An Coimisiún Pleanála, 64 Marlborough Street, Dublin 1. D01 V902.

Re: Observation to Strategic Infrastructure Development 323635 Garrane Green Energy Windfarm, located in the townlands of Garrane, Ballynagoul, Creggane and Charleville, Co. Limerick.

Figure 1 Location of Houses relative to wind turbines (From Appendix 14.4 of EIAR)

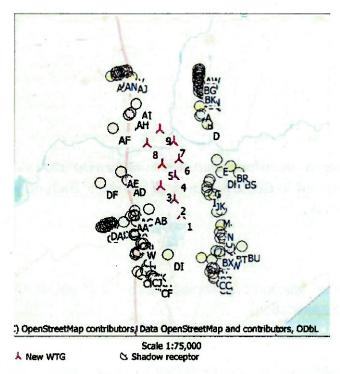
These houses are located to the east and west of the proposed wind farm primarily along the N20 and L1537 roadways. While a minimum setback distance of 680m from the nearest properties is maintained, the wind turbines are located in the middle of a ribbon like cluster of houses to east and west which has the potential for future conflicts and renders the site

totally unsuitable for wind turbine location. (See relative locations of houses and wind turbines in Fig 1 below)
